| APPLICATION NO. | FILING DATE | FIRST NAMED INVENTOR | ATTORNEY DOCKET NO. | CONFIRMATION NO. |
|-----------------|-------------|----------------------|---------------------|------------------|
| 10/757,629 | 01/14/2004 | Mark James Kline | 8194C | 4664 |

| Office Action Summary | Application No. 10/757,629 | Applicant(s) KLINE ET AL. | |

DETAILED ACTION

FIG. 1

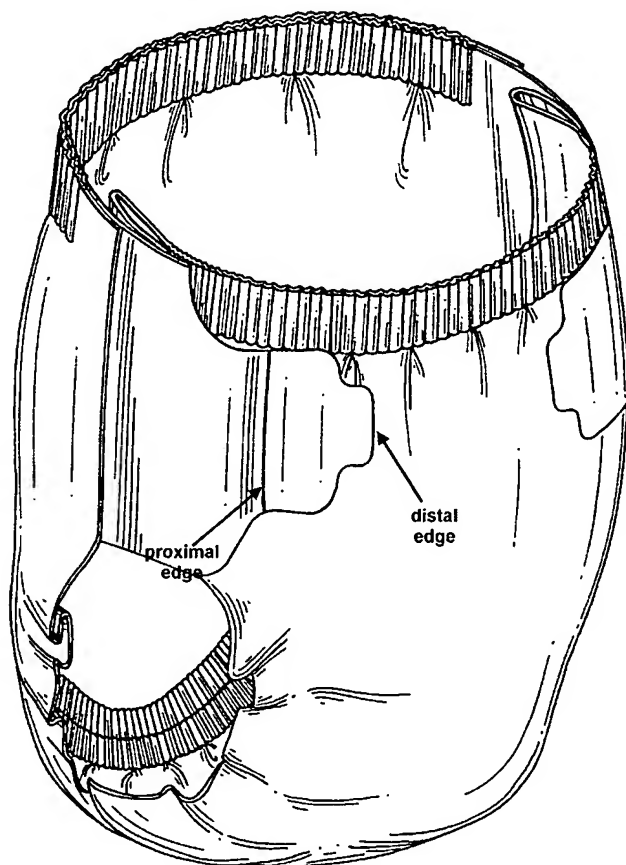
distal to proximal edge of the first fastening system. **Vukos** discloses disposable absorbent article to be worn about a user with a Y dimension increasing from a distal to proximal edge (figure 1).

One would be motivated to modify the fastening system of Schmidt with the increasing Y-dimension of Vukos since doing so would provide an easier mechanism to grip and open the tab and since both references disclose wearing articles with fastening systems. Therefore, it would be obvious to one of ordinary skill in the art at the time the invention was made to modify the fastening system, thus providing a fastening system with an increasing Y-dimension from the distal to proximal edge.

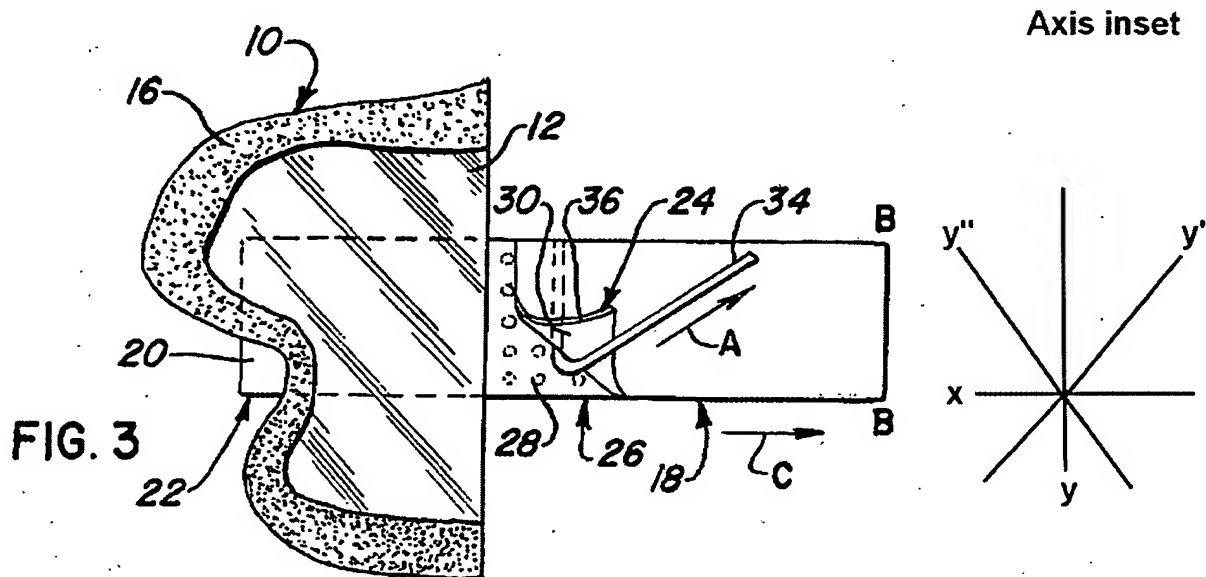
Regarding claim 4 Vukos further discloses the proximal/lower edge being longer than the distal/upper edge (figure 1).
